MEMO

RESPONSE ON ENGINEERING MATTERS - MINUTE 5 SHELLY BAY

TO Egmont Dixon DATE 30 July 2019

PROJECT NAME Shelly Bay ENVELOPE REF 1098-01

Shelly Bay Road plans

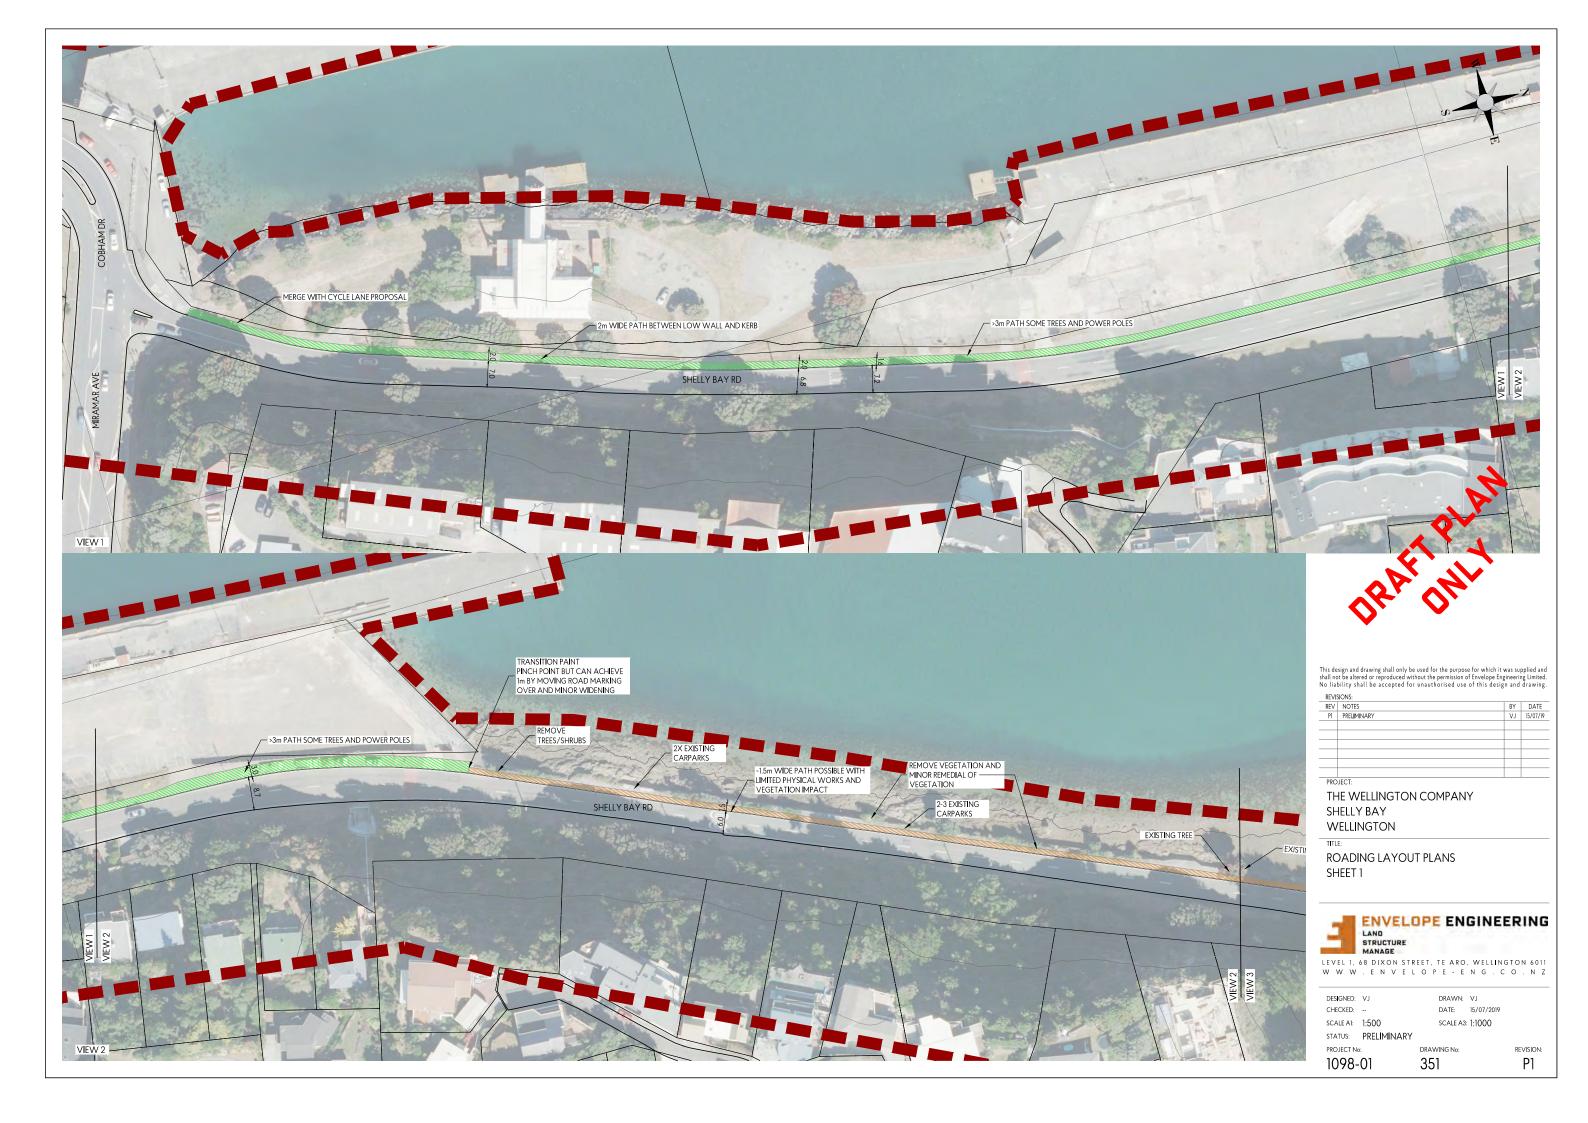
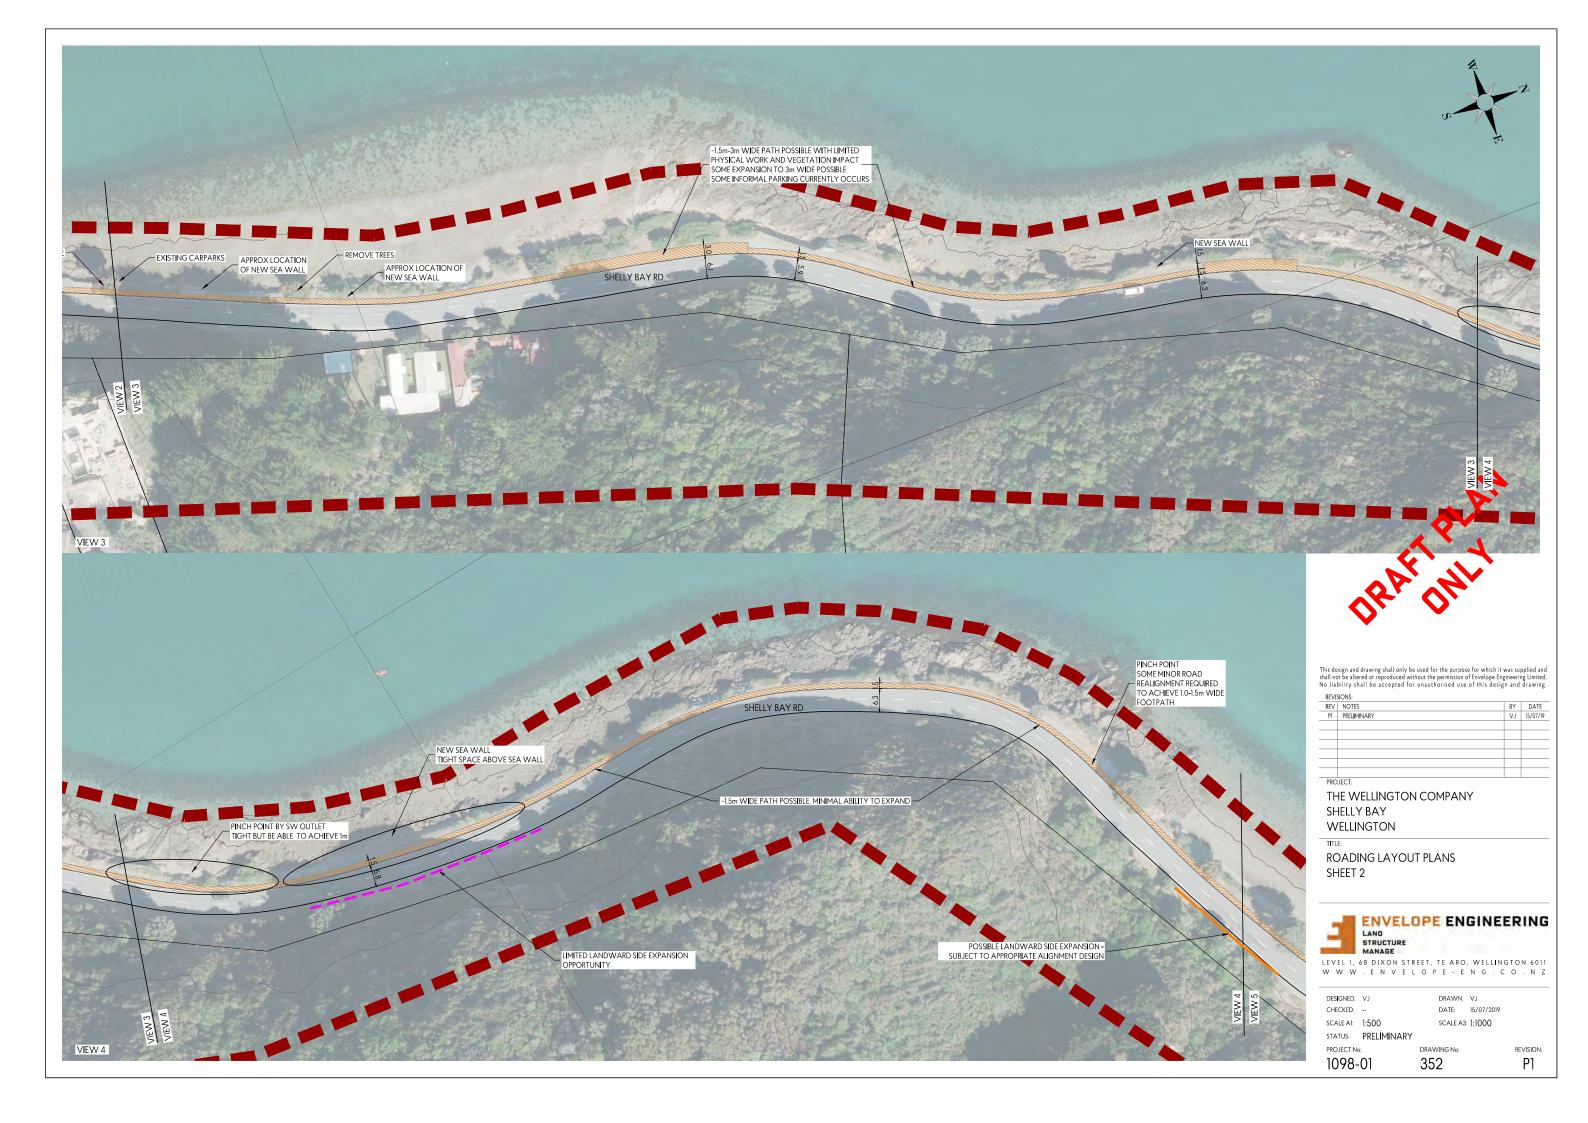
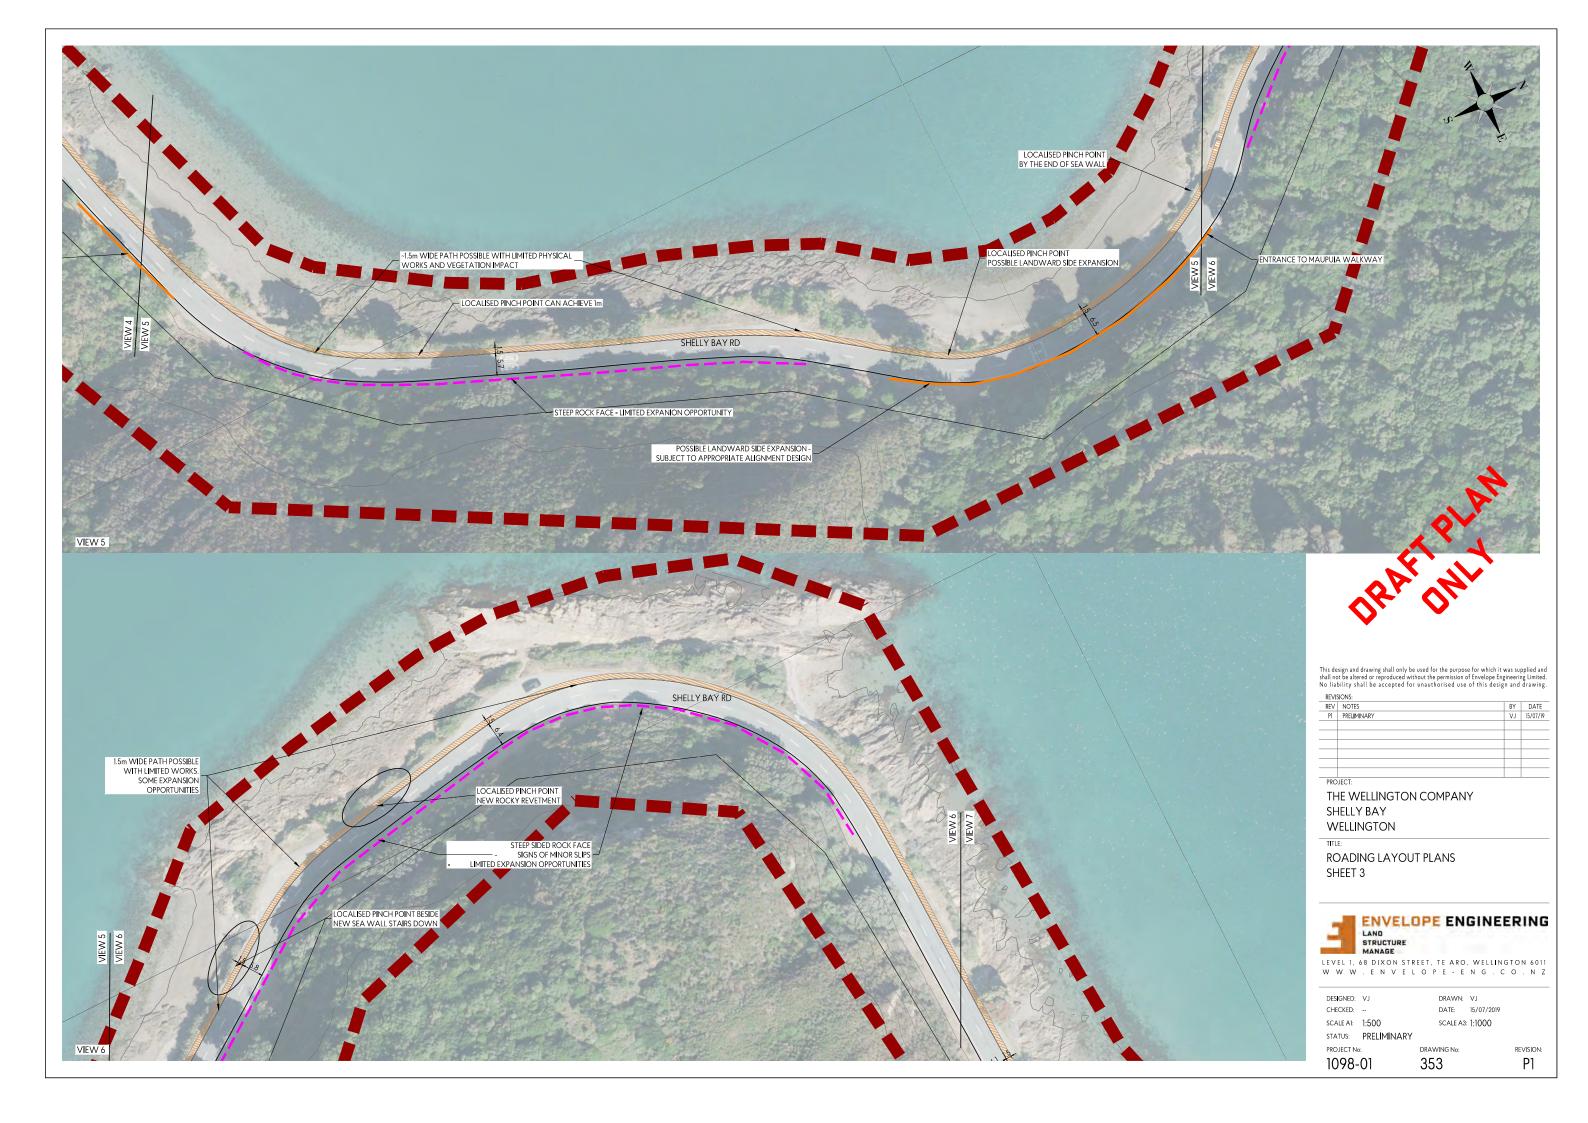
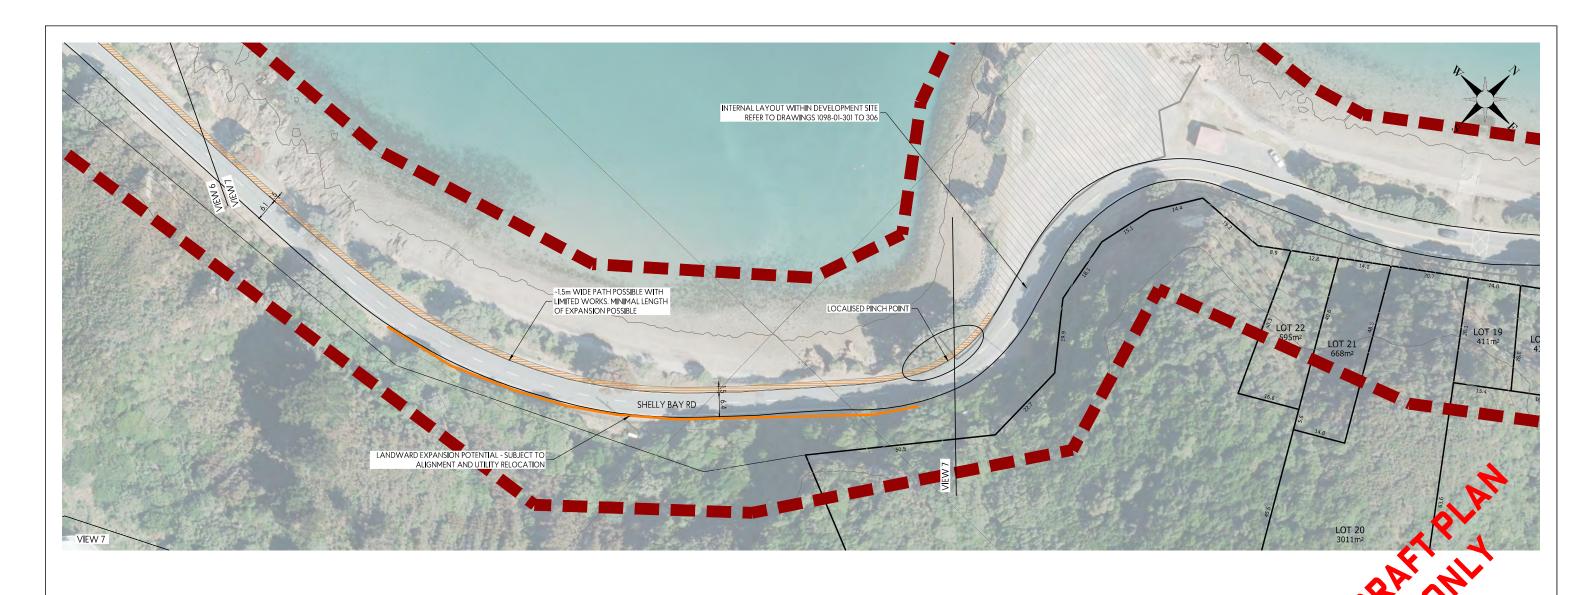
Based on the commentary by Stantec and earlier assessment and conclusions of Calibre, as well as Council's acceptance of these, we have prepared drawings showing the 6m wide carriageway along with a pedestrian path of at least 1m wide at pinch points but generally 1.5m wide, overlaid over aerial photo and council GIS location of existing road carriageway. The drawings (included here as Attachment 1) replicate earlier hand marked-up annotated plans prepared by Calibre and included within the aforementioned 2016 Calibre Servicing Feasibility Report.

I have walked along the entire Shelly Bay Road route between Miramar Avenue intersection and the Shelly Bay development area to confirm that the recommended 6m wide carriageway and 1.0-1.5m wide path can be accommodated. I am satisfied that a road carriageway and path of these dimensions can be constructed without the need to undertake any construction works within the CMA and without the need for building any additional sea walls or retaining structures on the seaward side of Shelly Bay Road.

I identified a number of pinch points where achieving a minimum 1.0m wide path would require a maximum of 0.5m of realignment of road carriageway and carriageway widening towards the land side of Shelly Bay Road. In all cases this localised realignment and/ or road widening could be readily accommodated within the usable land space available without the need for retaining or significant excavation. The indicative plans in Attachment 1 identify the pinch point areas.

Detailed plans of the 6m carriageway (showing centreline and edge lines painted white) as well as the proposed 1.0-1.5m path would be provided at Engineering Approval stage. The final surface formation of the path would be agreed with Council at this time also. We understand that discussions to date indicate this would be a crushed gravel/chip path. No kerb line is proposed to allow stormwater to continue to shed off the existing roadway as sheet flow.

The Shelly Bay Road improvements to provide a 6.0m wide carriageway and a 1.0-1.5m wide pedestrian/ cycle path are proposed to be completed prior to the completion and occupation of any new commercial or residential units at Shelly Bay development.
